Great River Hydro

**Re: Great River Hydro, LLC; FERC Project Nos. 1855-045, 1892-026, and 1904-073
July 12, 2017 through February 9, 2018 Study Report Addenda – Response to
Comments, Disagreements and Requests to Amend Study Plans**

Great River Hydro Response to Comments, Study Report Addenda filed July 12, 2017-February 8, 2018

Study 21, Comment #4 Additional Information: The plots show unadjusted (A) and adjusted (B) residency durations by route of passage for each fish.

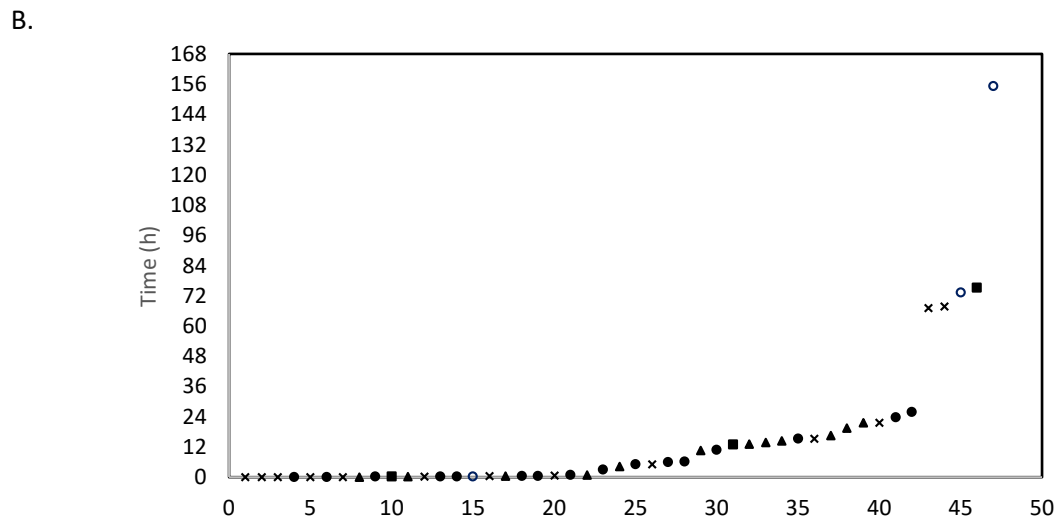
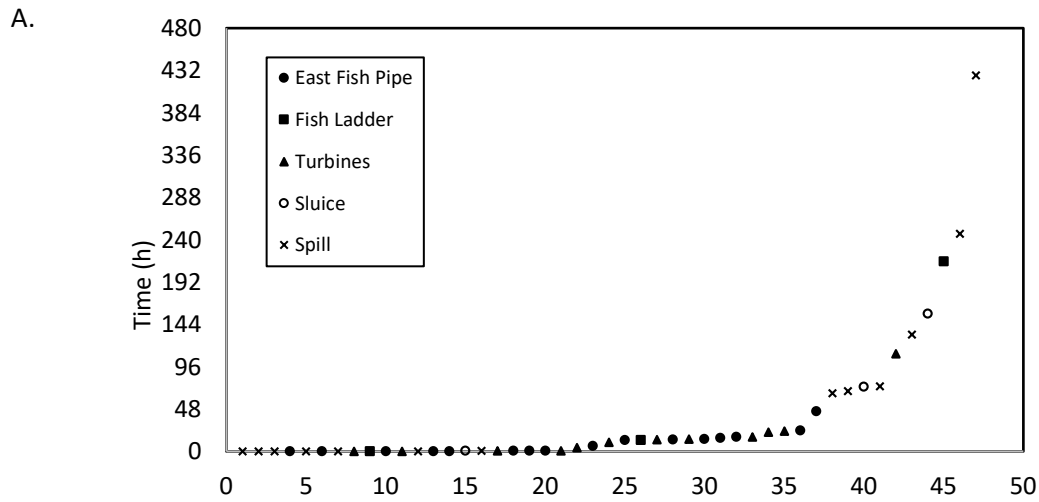
important to understanding each fish's complete history of movement within the project area.	
4	FWS	Also, we recommend supplementing the results of the forebay residency analysis with a data plot of tagged fish by the total period of time from first detection at MS-26 until passage (by any route) on the y-axis (see Figure 1, below). This figure will help better illustrate the range of observations.	The additional information requested is provided in the attached Additional Information document under Study 21, Comment 4.
5	FWS	In addition, we request that GRH provide a table that summarizes the number of movements and overall residence time for fish that ultimately passed the Project versus those that never passed.	The additional information requested is provided in the attached Additional Information document under Study 21, Comment 5.
6	FWS	While GRH did complete a desktop impingement, entrainment and survival analysis that included turbine survival estimates for adult shad-sized fish, that analysis does not (and cannot) provide survival estimates for non-turbine routes of passage. One way to fill this information gap would be for GRH to undertake a balloon tag study for adult shad (similar to ones it undertook for juvenile shad and adult eels), assessing all potential passage routes.	See response to Study 21, Comment 1.

The majority of total (unadjusted) residency durations were less than 24 hours. Eleven fish had unadjusted residencies of 24 hours to 247 hours. Those passed by all routes, but most (6) passed by spill. The adjusted residency durations removed periods of time when a fish was not present in the study area as determined by sequential detection upstream at MS-26. All but five fish had adjusted residency durations of less than 26 hours. The remaining five had substantially longer durations of 67 hours to 155 hours. Two of those passed via sluice and were noted in the report as potentially dead before passage. Two passed via spill and one passed via the fish ladder.
